REMARKS

Rejections Under 35 U.S.C. 112

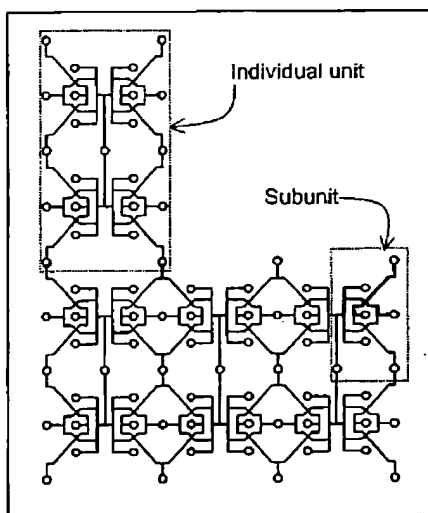
The next drawing highlights the relationship between the simple illustrations above and Figure 1B of the subject invention. An excerpt of the figure is

presented, showing 4 individual units, each having the four-fold symmetric arrangement of subunits and the eight-fold symmetric arrangement of single assay units. The components of one individual unit are shown bounded by the dotted rectangle, likewise for one subunit. Within the highlighted subunit, the components associated with one of the two single assay units therein is drawn with bold lines. The symmetry relating those two single assay units is evident, as is the symmetrical relationship among subunits. The same basic structures are found in Figures 2A, 2C and 3B, demonstrating the symmetric layout and the guiding principle of the fluidic designs.
